**RE: Opportunity to Address Comments Received for Agnico Eagle Mines Limited's
Meliadine Gold Mine Project 2022 Annual Report**

230608-11MN034-CIRNAC Comments-IA2E
230608-11MN034-HC Comments-IA2E
230615-11MN034-TC Comments-IT9E
230629-11MN034-ECCC Comments-IT9E
230630-11MN034-DFO Comments-IT9E
230630-11MN034-GN Comments-IA2E
230630-11MN034-KivIA Comments-IA2E
230630-11MN034-SDFN&NDFN Comments-IA2E

AGNICO EAGLE
MELIADINE

Figure 1: Tailings Process Water TDS with time (2019-2023)

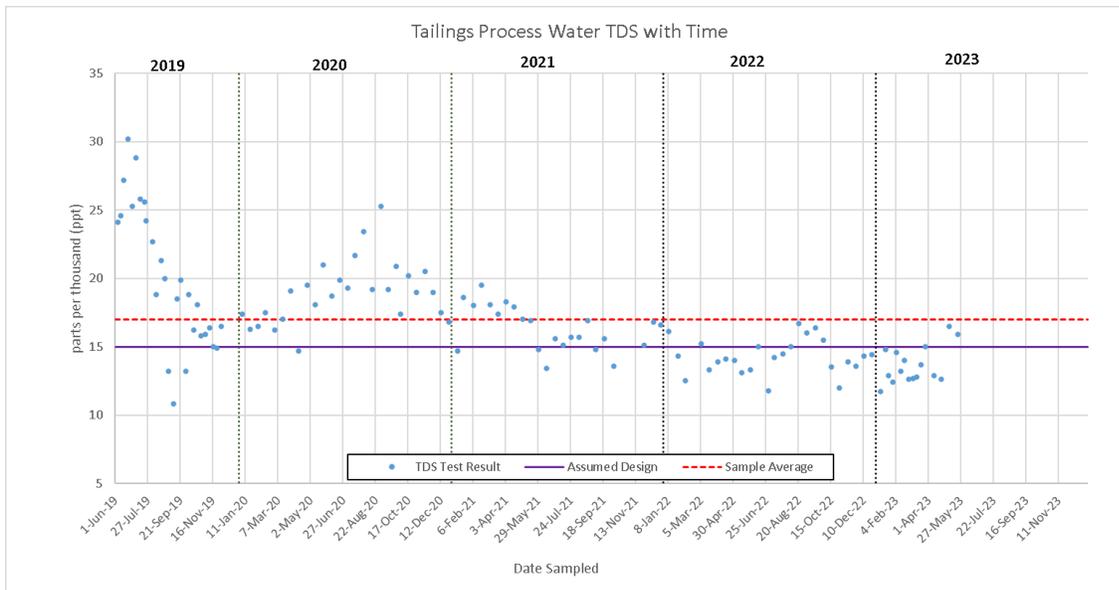
In order to verify that a potential environmental impact is not occurring, it would be helpful if AEM clarifies what the design assumptions are for the TSF with respect to tailings porewater salinity, and further describe, with some figures, the noted downward oscillating porewater concentration trend observed since initial tailings deposition.

1. Clarify why was it not practical in 2022 to use water from the Contact Water management facilities as Reclaim Water for milling purposes,
2. Clarify what the TSF design assumptions are with respect to tailings porewater salinity, which is a critical control parameter for the performance of the dry stack TSF, and
3. Provide further information to clearly illustrate and describe the observed oscillating decreasing trend in the tailings porewater salinity over time and the reason for the decreasing trend.

2. A porewater salinity of 15 ppt was assumed for the TSF design.
3. In 2019, the average porewater salinity was 20 parts per thousand (ppt) (TDS) with a min. of 11 ppt and a max. of 30 ppt. In 2020, the average porewater salinity was 19 ppt with a min. of 15 ppt and a max. of 25 ppt. In 2021, the average porewater salinity was 16 ppt with a min. of 13 ppt and a max. of 20 ppt. In 2022, the average porewater salinity was 14 ppt with a min. of 12 ppt and a max. of 17 ppt. Figure 1 below shows the TDS trend in the tailings process water between June 2019 and May 2023.

As stated in response to ECCC-2 above, starting in 2021, the average porewater salinity was marginally above the design limit and in 2022, the average porewater salinity was slightly below the design limit. Thus far in 2023, the average porewater salinity is below the design limit, with a few points at the limit and two points above it. Assessment into the impact of elevated salinity within the porewater on the TSF is ongoing, but the main impact will be freezing point depression, which may alter the thermal performance of the TSF from that which was predicted in design. The laboratory testing conducted to measure the freezing point temperature is only slightly lower (-0.02°C) than what was assumed during the design.

Porewater salinity has no impact on the physical performance of the tailings themselves. No negative impact to the physical stability of the TSF is expected due to a potential change in the thermal performance of the facility, as the facility was designed to remain physically stable under fully thawed conditions.
